FACILITY COMPLIANCE AUDIT REPORT
Division of Waste Management
Solid Waste Section

Date of Audit: 02/02/11

Grandfather Golf & Country Club Landfill, Newland
 Tax Parcel No. 1837 2082 7248
 Hickory Gap Road
 Newland, NC
 (Approximately 4-miles north of Newland, on the right, past Hickory Estates Lane.)

Figure 1. Avery County GIS Aerial of Tax Parcel No. 1837 2082 7248
Approximate Limits Area of Waste

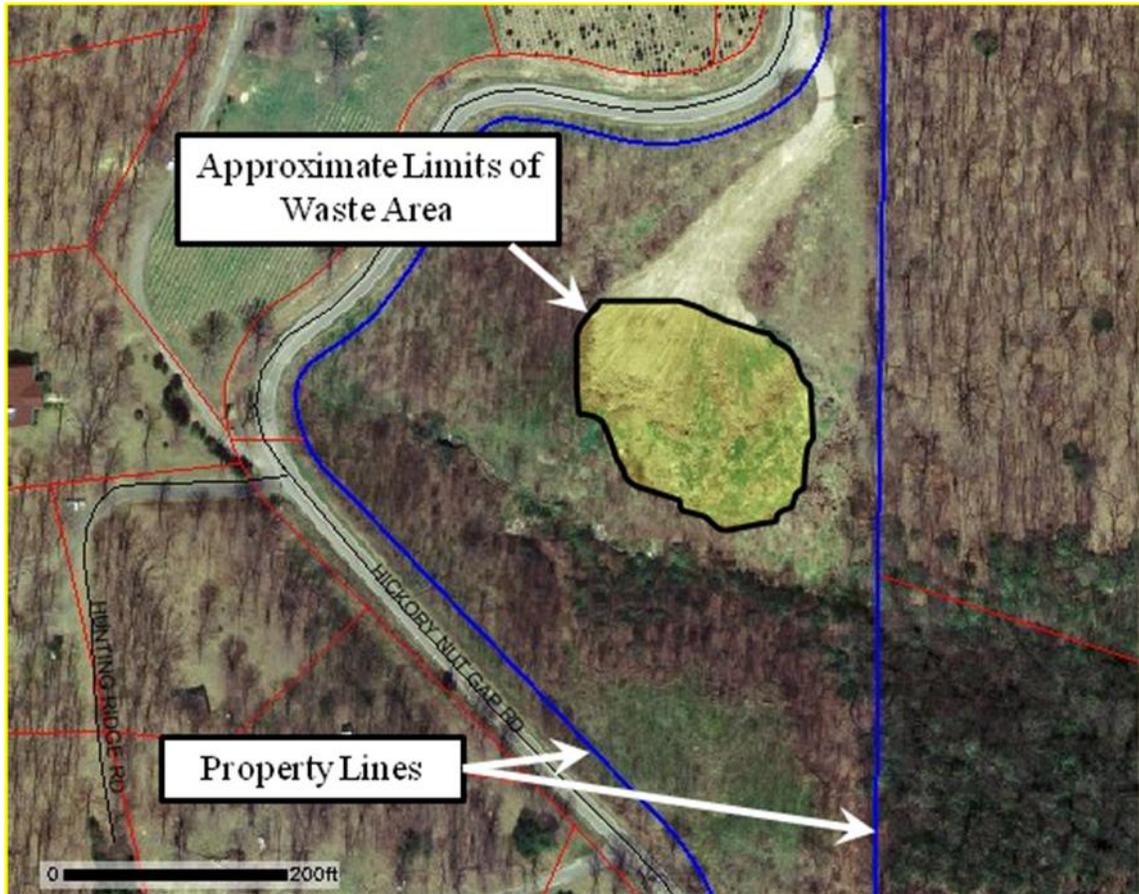
1. Site inspection was conducted to verify the location and status of the facility and to determine if facility is in compliance with the operational requirements.
2. Access to the site is properly controlled with a locked gate.
3. Based on the Avery County Geographic Information System (GIS) map of the landfill parcel, it appears that the required 100-ft. buffer from waste disposal areas to property lines is not being maintained on the eastern side of the facility. (Figure 1)

4. As it is difficult to determine if 100-ft. buffer requirement is being adhered to without first knowing where the edge of waste and the property lines are located, please identify and mark the property line(s) and the waste limits.
